Keithley Instruments  
28775 Aurora Road  
Cleveland, Ohio 44139  
1-800-833-9200  
[tek.com/keithley](http://tek.com/keithley)

Model DMM7512 7½ Digit Graphical Multimeter

## VERSION 1.7.7 RELEASE

PR54974, UI graph occasionally appears to be missing digitizer data  
PR54934

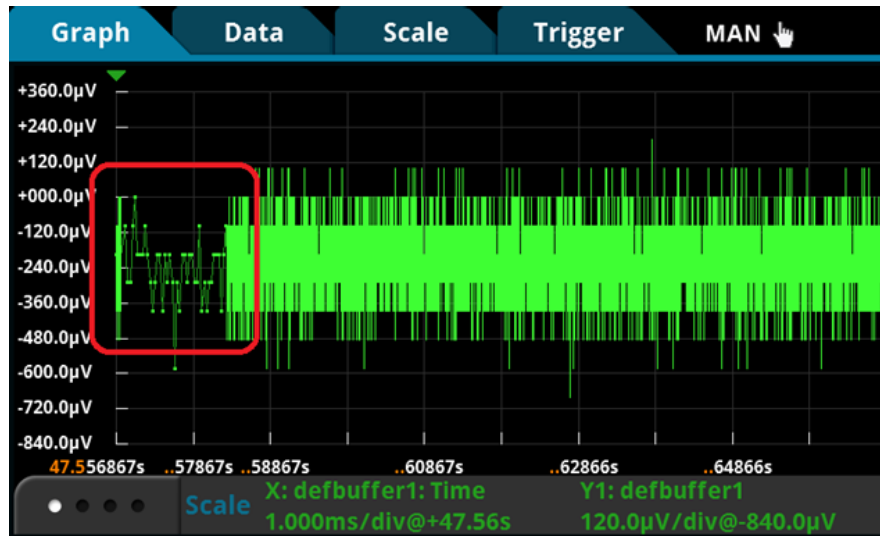
When using the UI to view bursts of digitizer data on the graph, you may see areas that appear to have missing data. See the example in the image below. Even though data is being sampled consistently throughout the viewable range, it appears as though fewer points are available in the circled area.

This may only occur when more than 5,000 points are visible on the graph at once and sample rates exceed 50k.

Pan or scale the graph by touching it to force a refresh. All data will appear. The measurements were taken and are in the buffer.
